Subject: Annual Inspection Report
Floralia Municipal Airport

Annual Inspection Report Floralia Municipal Airport Floralia, Alabama

June 19, 2007

Photo #1 – Runway Approach / Departure Violation

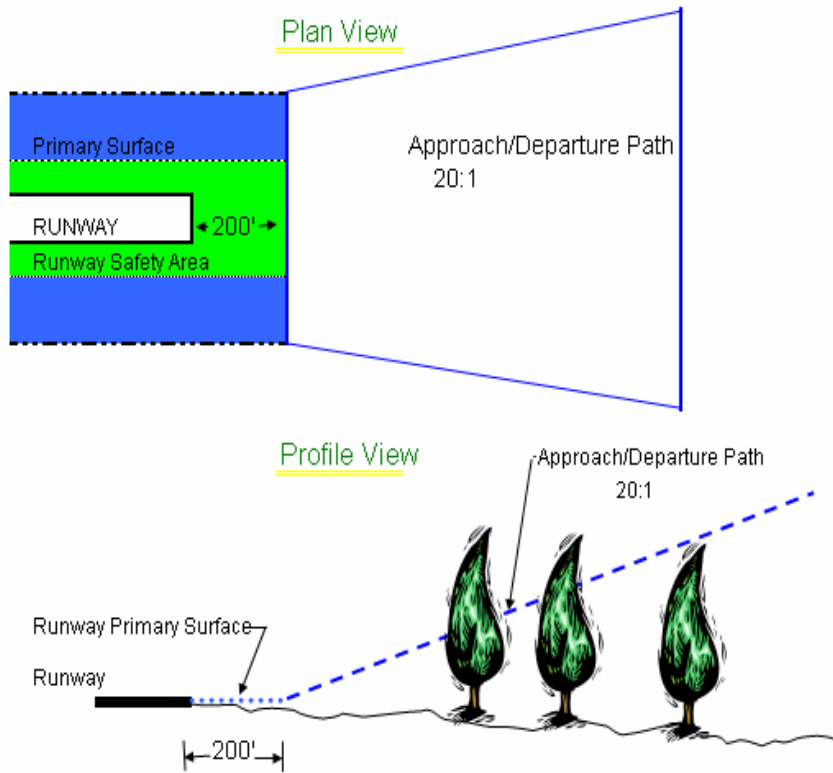
- The approach and departure paths for each end of Runway 4/22 were inspected with the following violations found:
- **Violation:** Runway 4 – A tree identified as Tree # 1 obstructs the approach/departure path of runway 4 (See Photo # 1 & Appendix 2).

- While this tree is representative of obstructions in the approach departure path of runway 4 it may not include all the trees that violate the 20:1 approach departure path.
- In order for an operating license to be issued the obstructions to runway 4 must be removed.
